# Consolidated Stakeholder Responses to Post- Workshop Questions on CPUC's SB-884 Guidelines

# Post-Workshop Questions for Stakeholders Regarding the CPUC SB 884 Guidelines

**Subject: Public Advocates Office's Informal Comments on Planning Questions  
for Stakeholders Regarding the CPUC SB-884 Guidelines**

**Figure 2** - PG&E's risk multipliers for different levels of consequence. Categories are Retention (<\$100m), Insurance-based (\$100m-\$1b), and Catastrophic (>\$1b).<sup>26</sup>

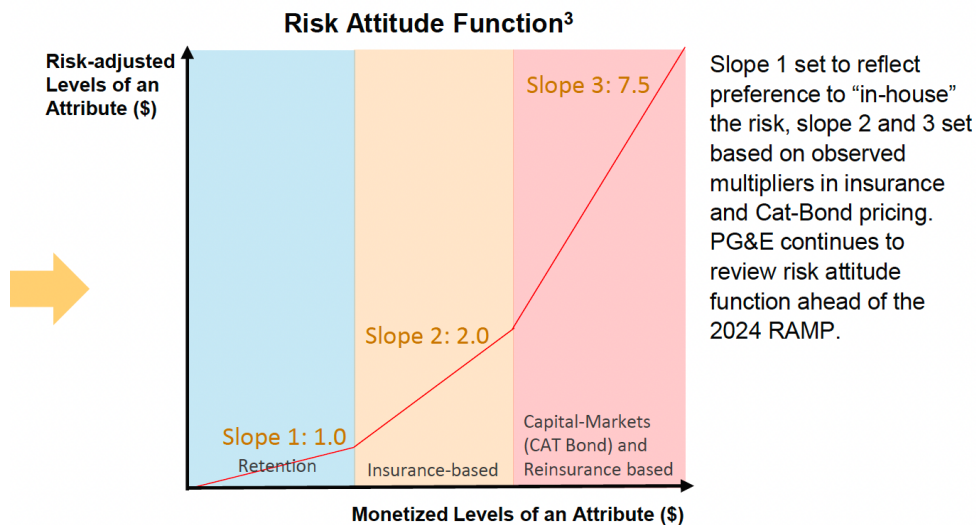
PG&E has adopted a novel method for risk scaling, adopting a “Risk Premium Multiplier” to create a risk-averse attitude in its scaling function. It defines three ranges for its risk scaling function: Routine, Elevated, and Catastrophic, where “Catastrophic” is defined as losses over \$1 billion, while the Elevated range describes losses between \$100 million and \$1 billion.<sup>25</sup>

As seen in Figure 2, PG&E’s risk function uses a multiplier for each attribute level. PG&E’s method for obtaining its Catastrophic multiplier “is to use available, objective data to determine the Risk Scaling Function(s). Risk Premiums/Prices from Insurance and Capital Markets meet these
